Department of Energy
National Nuclear Security Administration
Washington, DC 20585

This letter is in response to your November 19, 2012, letter concerning the approved but not yet implemented 2012 upgrade to the nuclear facility safety basis for Area G at Los Alamos National Laboratory. Specifically, the Board's letter stated that the Area G safety basis approved in March 2012, included inconsistencies with Department of Energy (DOE) Standard 3009-94, *Preparation Guide for U.S. Department of Energy Nonreactor Nuclear Facility Documented Safety Analyses*. Three specific inconsistencies were cited in the Board's letter with additional issues described in an enclosed report.

Enclosure: Detailed Response to DNFSB letter of November 19, 2012

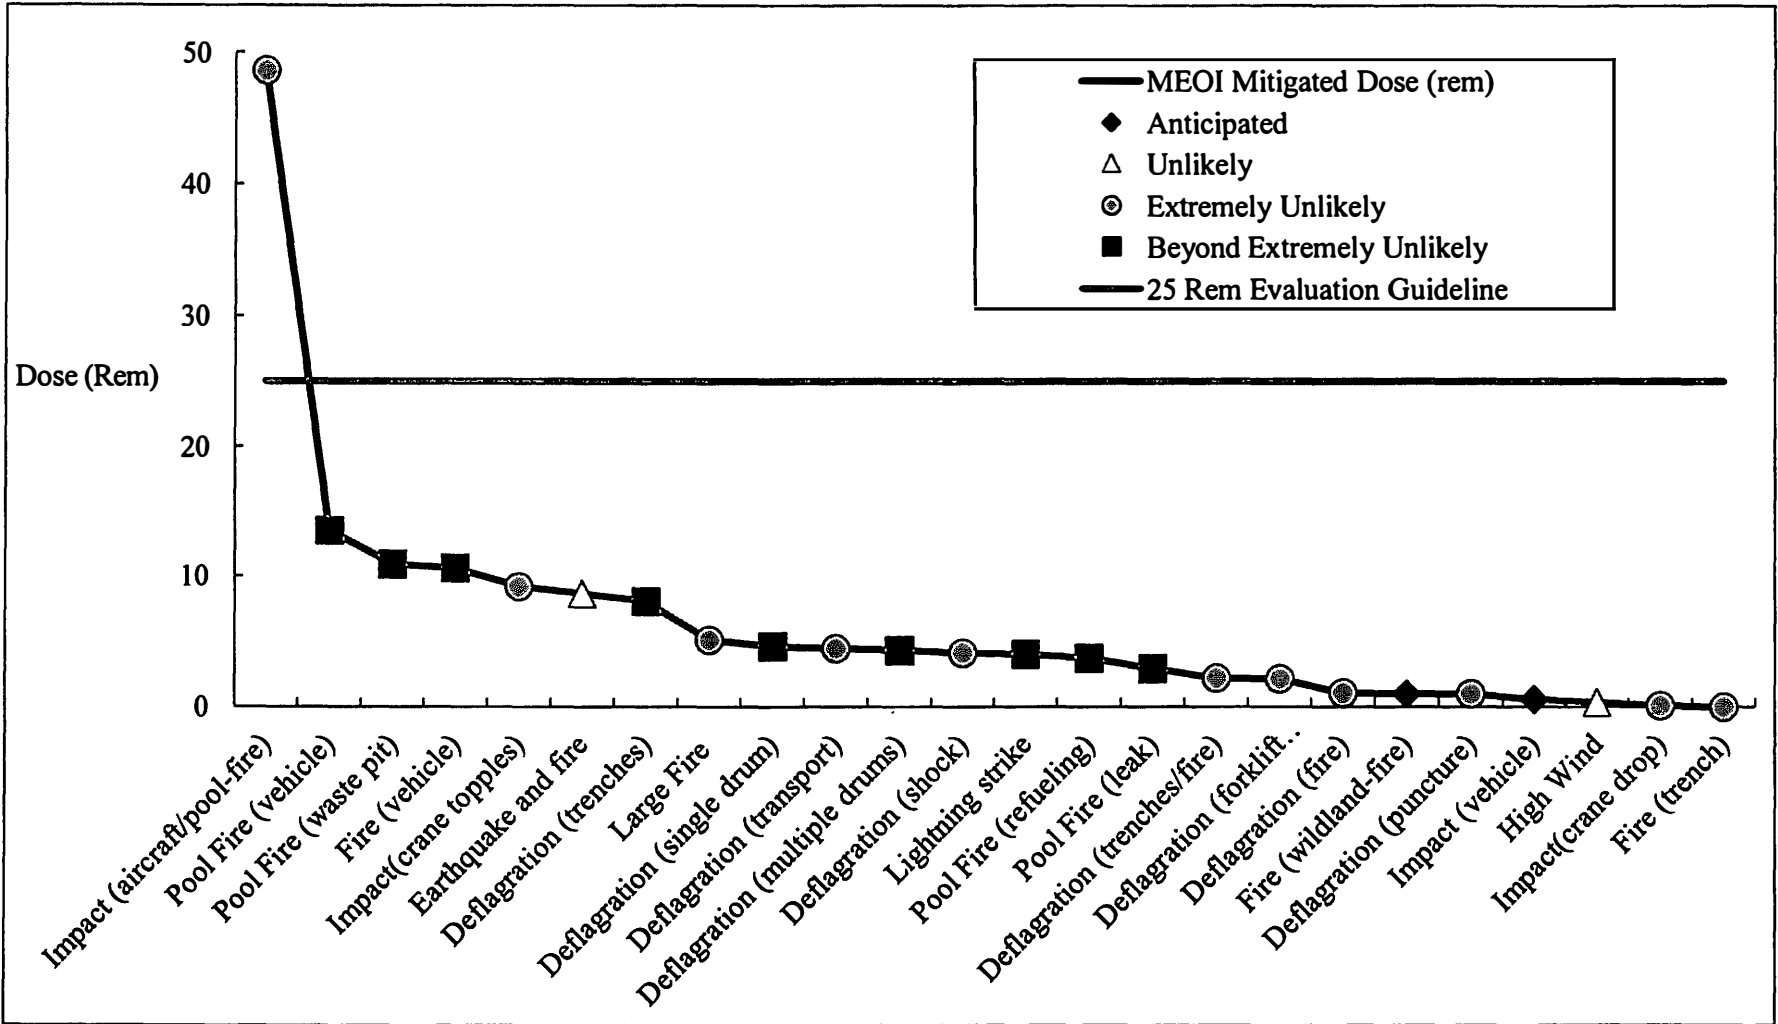
For perspective, Figure 1 presents the calculated mitigated accident frequencies and mitigated doses to the maximally exposed off-site individual (MEOI) for the two dozen detailed accident analyses in the 2012 DSA. The frequency bins (e.g., Anticipated, Unlikely, etc.) correspond to those identified in Department of Energy (DOE) Standard 3009. One accident scenario, the aircraft crash and fire, had calculated consequences exceeding the DOE 25 rem Evaluation Guideline. NNSA accepted this result based on:

NNSA Analysis: The hazard analyses in both the currently implemented and the new but not yet implemented DSA also include deflagration/fire scenarios that are caused by accumulation of flammable airborne concentrations above the lower flammability limit following a gasoline or propane fuel leak or spill. Figure 1 indicates that the 2012 DSA accident analyses included 9 deflagration scenarios and 8 other fire scenarios. The scenarios already covered in the hazard and accident analyses may bound the scenario posed by the DNFSB and its staff.
